Access Compliance Report

Intersection ID: 16598	Main Street: CRAIG_AV	Cross Street: RICHLAND_DR	Location:	N
ADA ID: 605C4672CF9B	Ramp Type: PerpDiag	Initial Pass/Fail: Fail	Overall Compliance: No	Severity Score: 25
Codes/Mitigation Info/Possible Solution		Field Measurements/Component Compliance

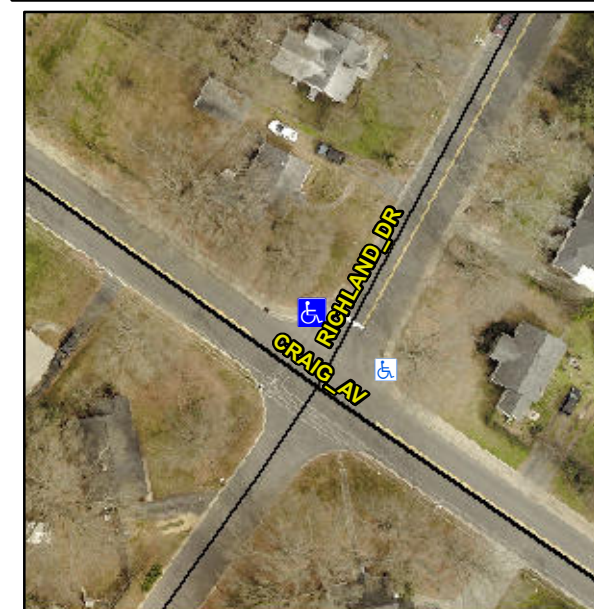
Not Found, R304.2.2

Compliance	Description	Data	Compliance	Description	Data
N/A	Ramp Length (in)	40.0	No	Ramp Slope (%)	14.4
Yes	Ramp Width (in)	48.0	Yes	Ramp XSlope (%)	1.1
N/A	Flare Type LT	N/A	N/A	Flare Type RT	N/A
N/A	Flare Slope LT (%)	N/A	N/A	Flare Slope RT (%)	N/A
N/A	Flare Traversable LT?	N/A	N/A	Flare Traversable RT?	N/A
N/A	Landing Length (in)	N/A	N/A	DWS Provided?	N/A
N/A	Landing Width (in)	N/A	N/A	DWS Contrast?	N/A
N/A	Landing Slope (%)	N/A	N/A	DWS Length (in)	N/A
N/A	Landing X Slope (%)	N/A	N/A	DWS Full Width?	N/A
N/A	Landing Curb? (Y/N)	N/A	N/A	DWS Offset (in)	N/A
N/A	Shared Landing?	N/A			
N/A	Gutter Ponding?	N/A	N/A	Gutter Slope (%)	N/A
N/A	Gutter Lip Ht (in)	N/A	N/A	Gutter X Slope (%)	N/A
N/A	Painted X Walk1?	No	N/A	Painted X Walk2?	No
	X Walk 1 Direction	To SW		X Walk 2 Direction	To SE
N/A	X Walk 1 Width (in)	N/A	N/A	X Walk 2 Width (in)	N/A
	X Walk 1 Slope (%)	2.6		X Walk 2 Slope (%)	2.3
	X Walk 1 X Slope (%)	0.5		X Walk 2 X Slope (%)	0.3

Remove & Replace Curb Ramp With Two New Directional Ramps or Equivalent.
